Re: RADWP Addendum
Area B: Sub-Parcel B1-1
Tradepoint Atlantic
Sparrows Point, MD 21219

<p>Sub-Parcel B1-1 Stormwater Tie-In Location February 20, 2020</p>		<p>Figure 1</p>
 	<p>EnviroAnalytics Group ARM Project 160443-18 Tradeport Atlantic Baltimore County, MD</p>

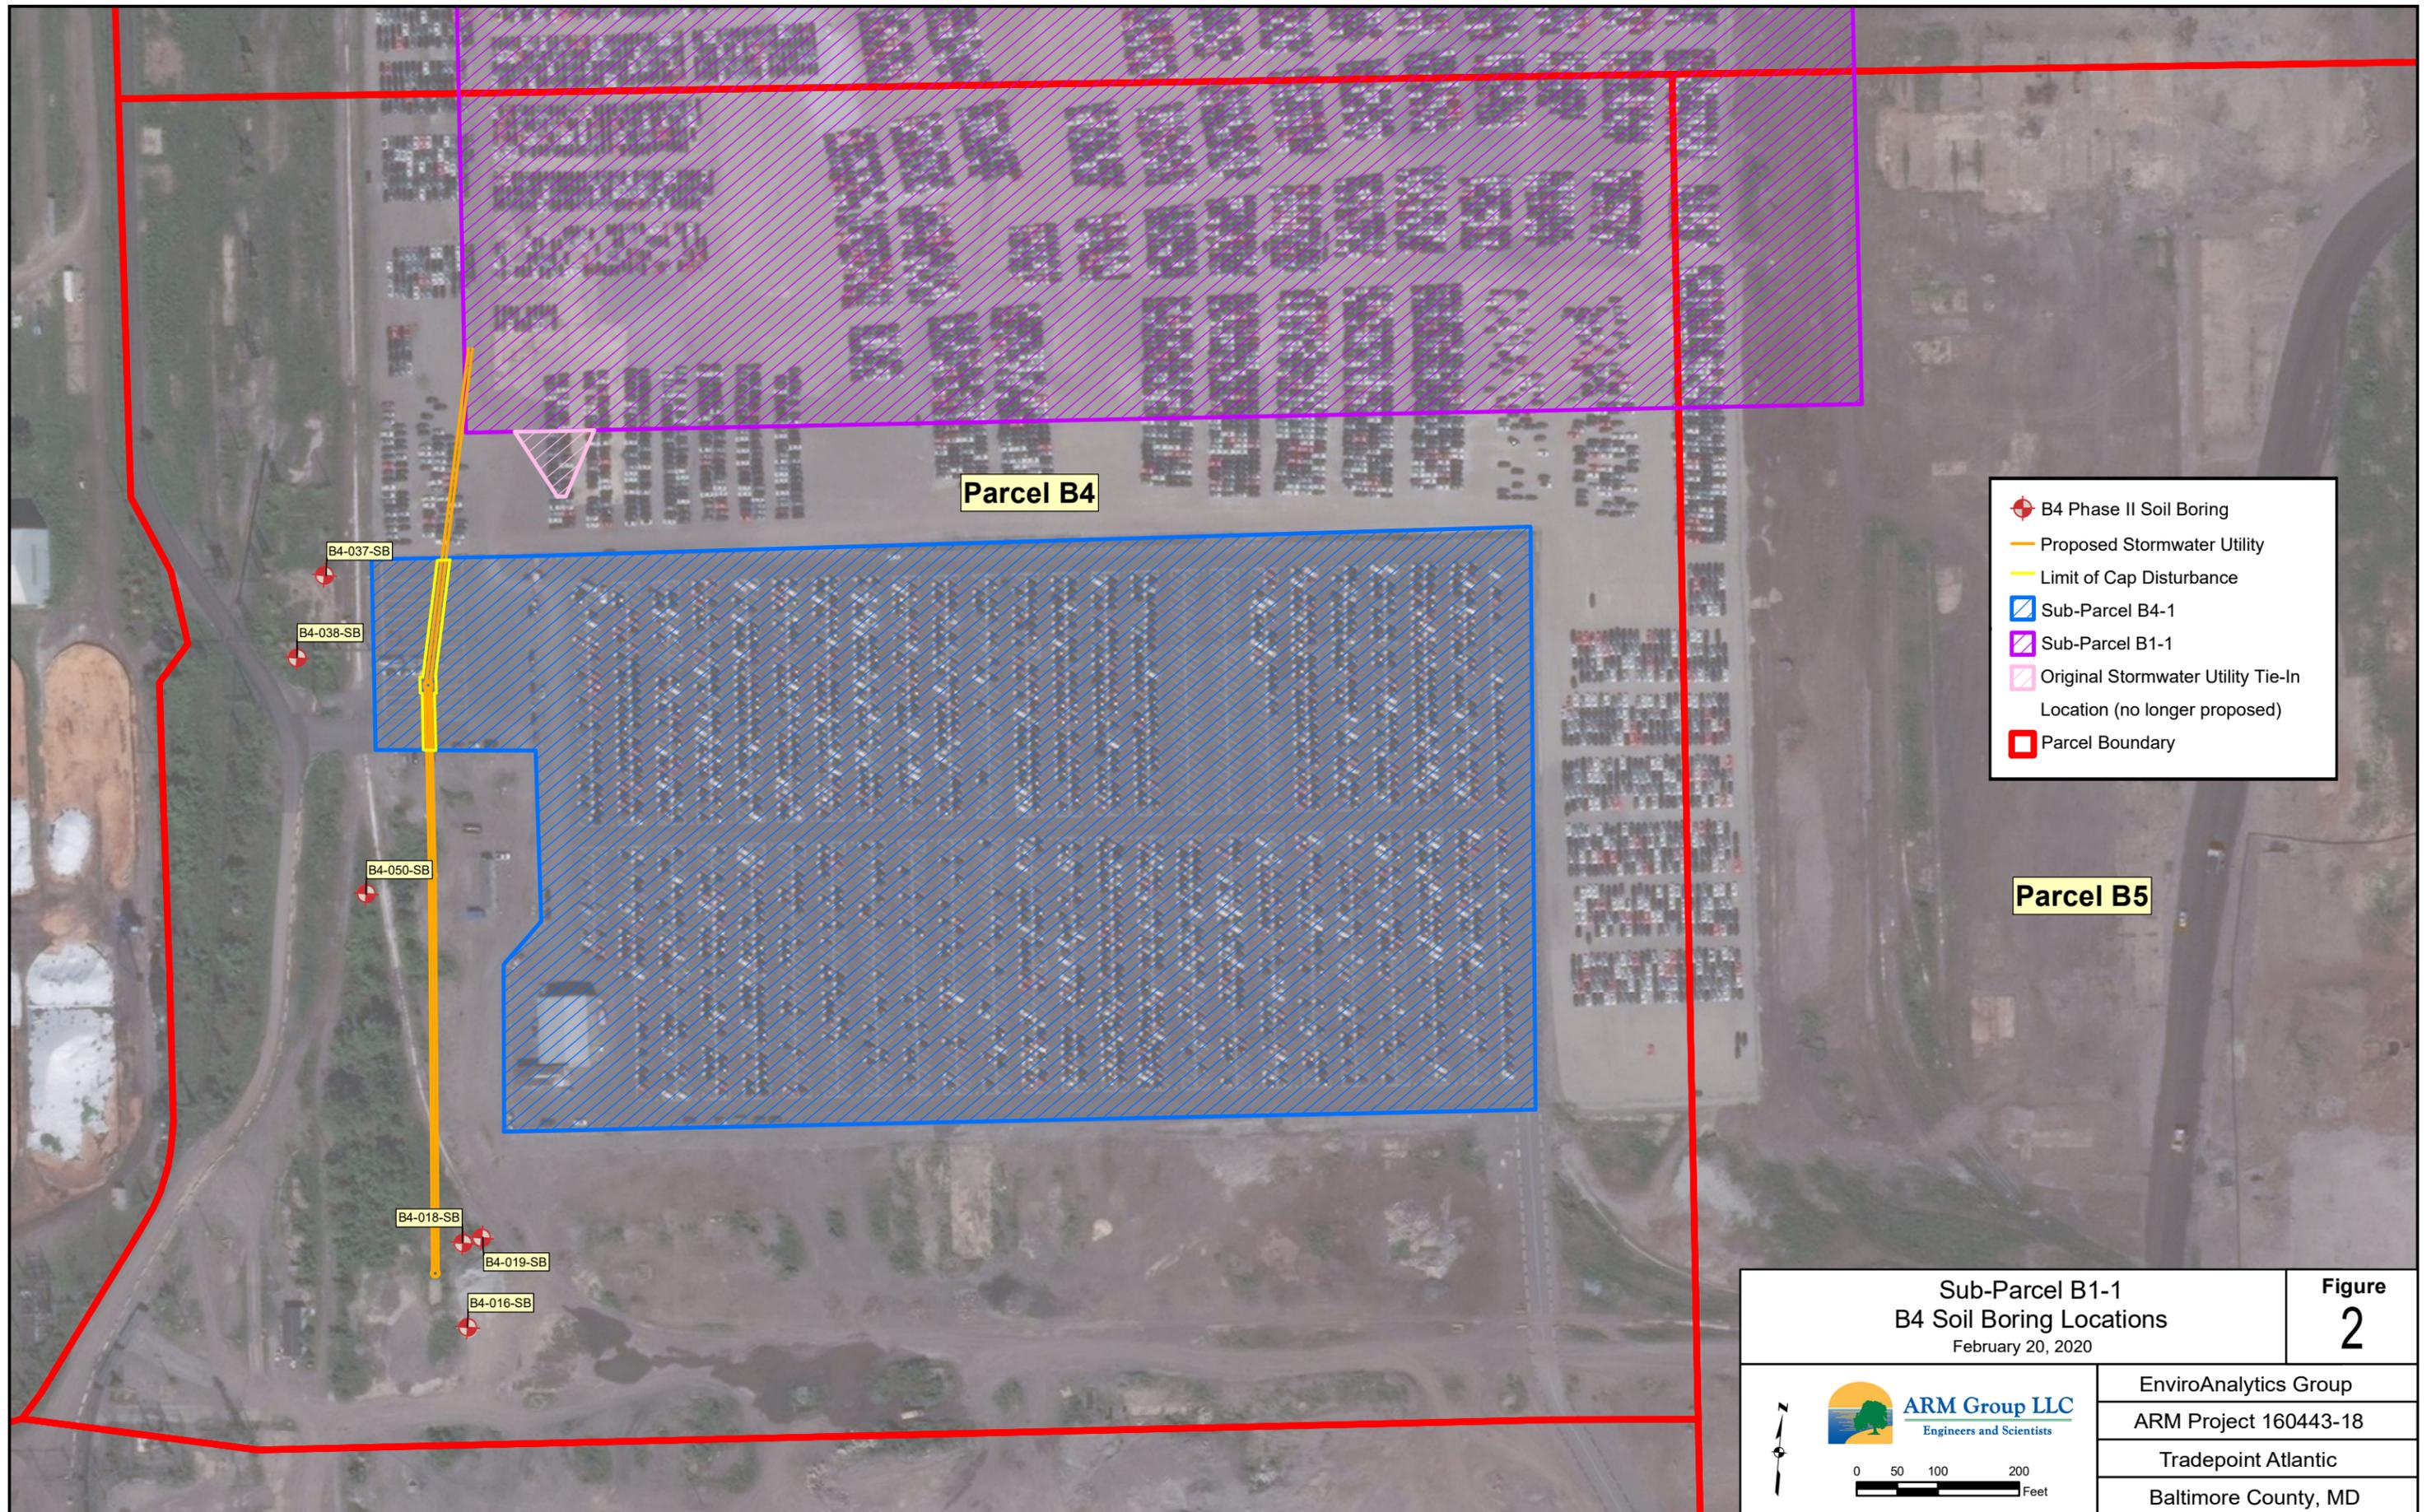
Appendix A contains the project construction drawing for the proposed work. *Sheet C2.05A* details the proposed stormwater utility extension and highlights the area where existing pavement within Sub-Parcel B4-1 is to be disturbed via a saw cut. **Figure 1** provides an overview of the proposed work, incorporating the information shown on *Sheet C2.05A* to indicate the amended stormwater utility alignment as well as the associated limit of disturbance (LOD) within the Sub-Parcel B4-1 pavement cap. Note that, because the utility tie-in has changed, soil disturbance within a portion of the originally proposed stormwater utility tie-in location is no longer necessary.
